**Re: Sable Road  
Applications for Land Use Permit and Class "B" Water License  
Information Requests Dated May 23<sup>rd</sup> and 25<sup>th</sup>, 2001**

INFORMATION REQUEST  
DIAND – May 22, 2001

INFORMATION REQUEST  
DIAND Lands – May 25, 2001

Figure 1  
Falcon Lake Access Road  
Preliminary Design

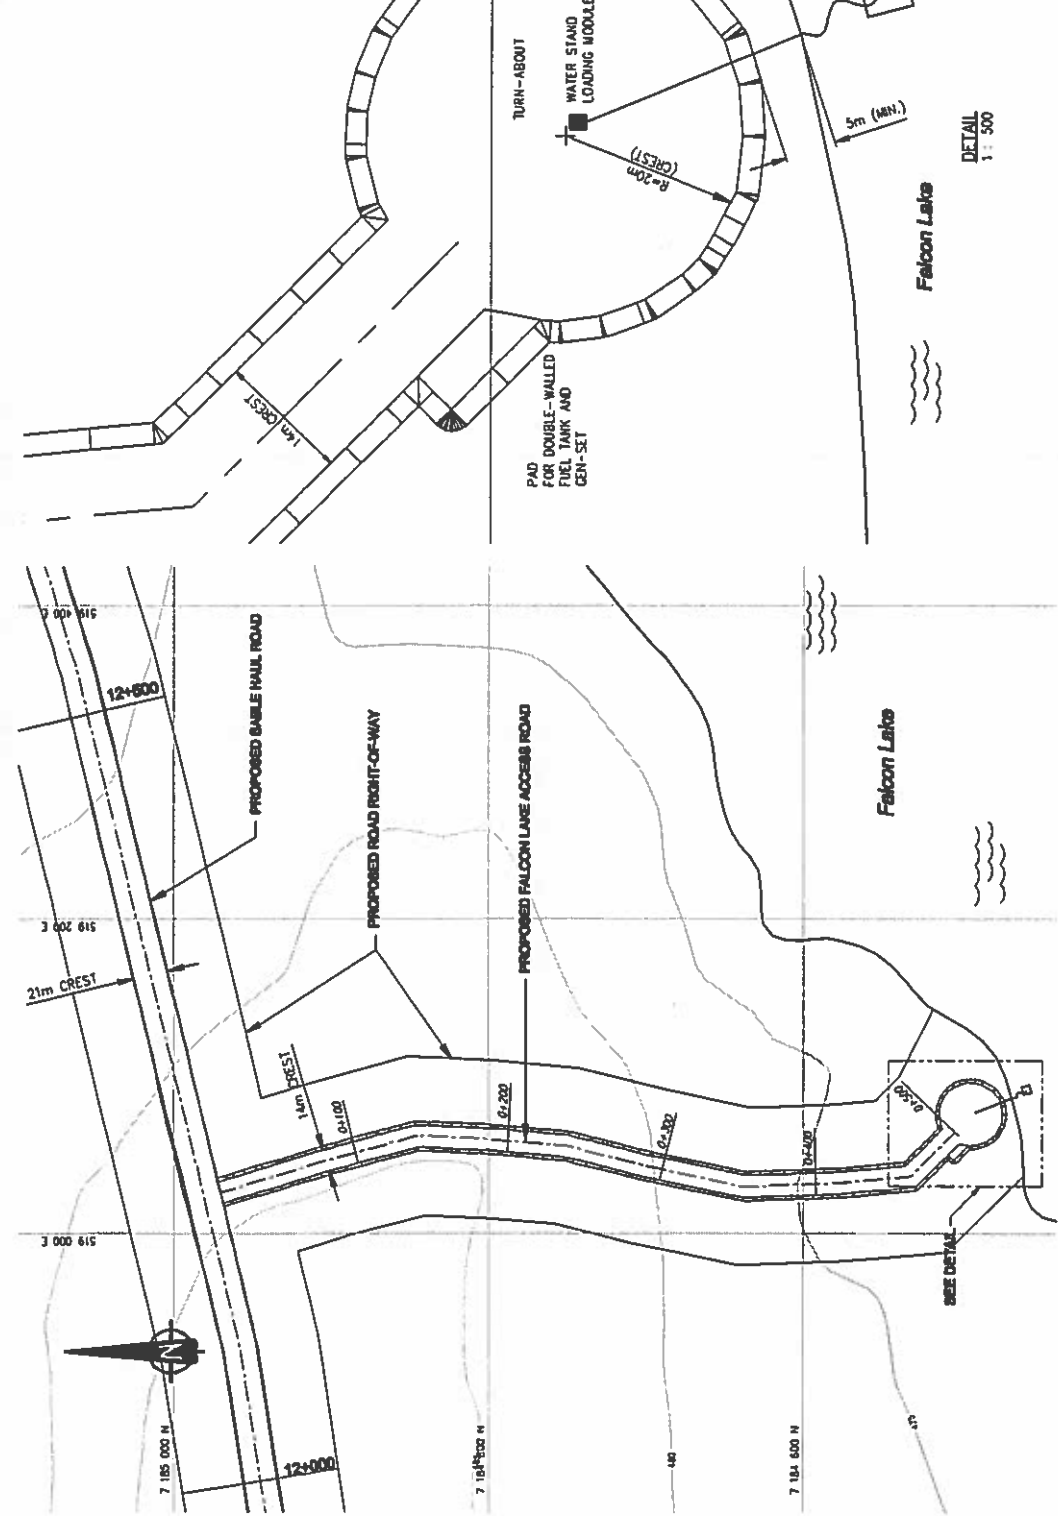
For the access road to Falcon Lake, details on the road design; base width, crest width, is there a truck turn around, does it go to the ordinary high water mark at the edge of the lake?

For the water application, is this a pump design with a intake hose put into the water at a certain depth? What is fuel storage for the pump?

A drawing of the access road to Falcon has been attached for information. This drawing represents conceptual design of the access road developed from available mapping of the land in the area. Further site reconnaissance will be completed in the summer of 2001 to develop final design. As shown on the drawing, the road itself will be of similar design to the main haul road. The road will be designed as a single lane for use by a CAT 777 water truck with a turn-around. The road will not extend beyond the high water mark of Falcon Lake.

- A submersible pump (preliminarily sized at 90 horsepower) will be used to pump water from Falcon Lake. The pump will be installed on a float system so that water will be removed from the upper surface of the lake and will be positioned within at least 3 metres of water. An intake line and screen will be installed in accordance with guidelines established by the federal Department of Fisheries and Oceans.

- A high density polyethylene pipeline will deliver water from the pump to a pipe stand. The pipe stand will be located on the access road turn-around and will be a steel structure that the water truck drives underneath to receive water. The water truck driver will turn the water pump on and off from the pipe stand.

- The water pump is electric. A portable diesel generator will be used to generate the needed electricity. A double wall fuel storage tank will be stored on a pad adjacent to the turn-around. Both the generator and the associated fuel storage tank will be located at least 30 metres away from the high water mark of Falcon Lake.

Figure 1  
Falcon Lake Access Road  
Preliminary Design

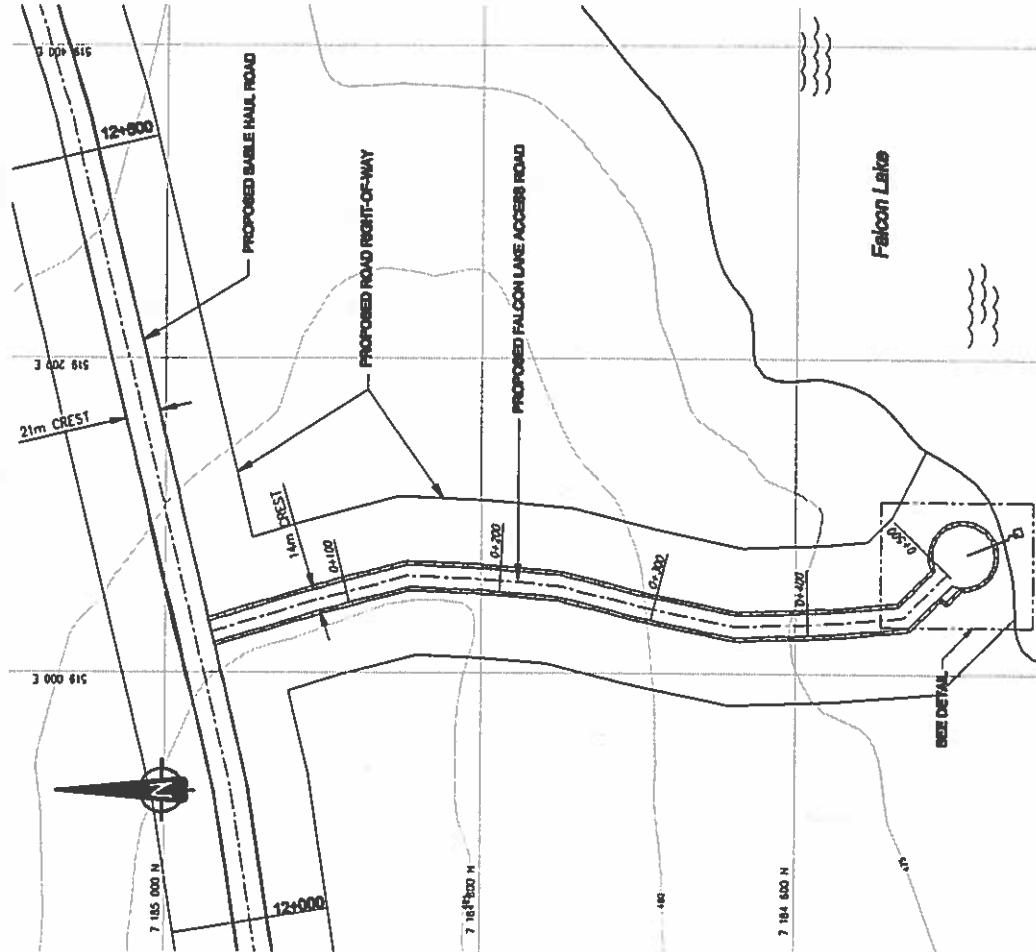
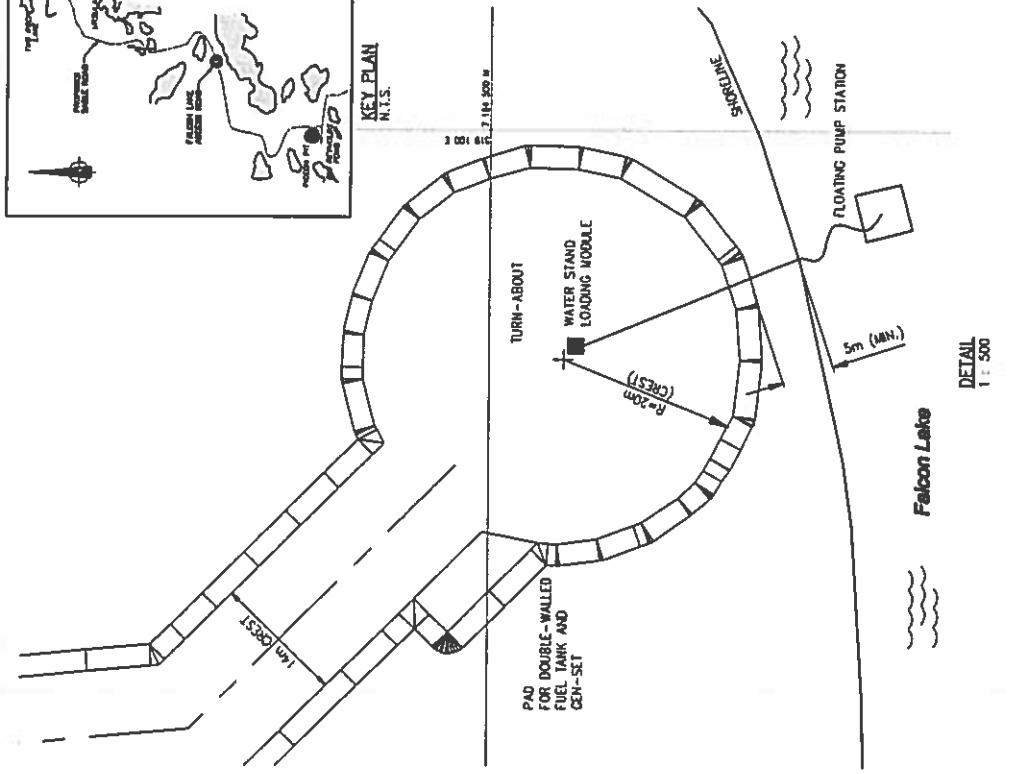
- location and quantity of granular material to be used for the construction of the turnaround area, road, etc
- construction requirements for the water intake, any building, pad, etc
- estimated cost to abandon and restore this facility including the plan to undertake the work
- site plan/plot plan of facilities showing dimensions and area
- description of use and duration of facilities.

As stated in Section 3.2 of the design brief, general fill material for the Sable Haul Road will be from operations at Koala and Panda pits. The same fill source will be used for the Falcon access. Surface course material will be obtained from either the Airstrip esker and/or crushed run-of-mine from Panda and/or Koala pits.

A drawing of the access road to Falcon has been attached for information. This drawing represents conceptual design of the access road developed from available mapping of the land in the area. Further site reconnaissance will be completed in the summer of 2001 to develop final design. As shown on the drawing, the road itself will be narrower, but of similar design to the main haul road.

- A submersible pump (preliminarily sized at 90 horsepower) will be used to pump water from Falcon Lake. The pump will be installed on a float system so that water will be removed from the upper surface of the lake and will be positioned within at least 3 metres of water. An intake line and screen will be installed in accordance with guidelines established by the federal Department of Fisheries and Oceans.

- A high density polyethylene pipeline will deliver water from the pump to a pipe stand. The pipe stand will be located on the access road turn-around and will be a steel structure that the water truck drives underneath to receive water. The water truck driver will turn the water pump on and off from the pipe stand.
- The water pump is electric. A portable diesel generator will be used to generate the needed electricity. A double wall fuel storage tank will be stored on a pad adjacent to the turn-around. Both the generator and the associated fuel storage tank will be located at least 30 metres away from the high water mark of Falcon Lake.
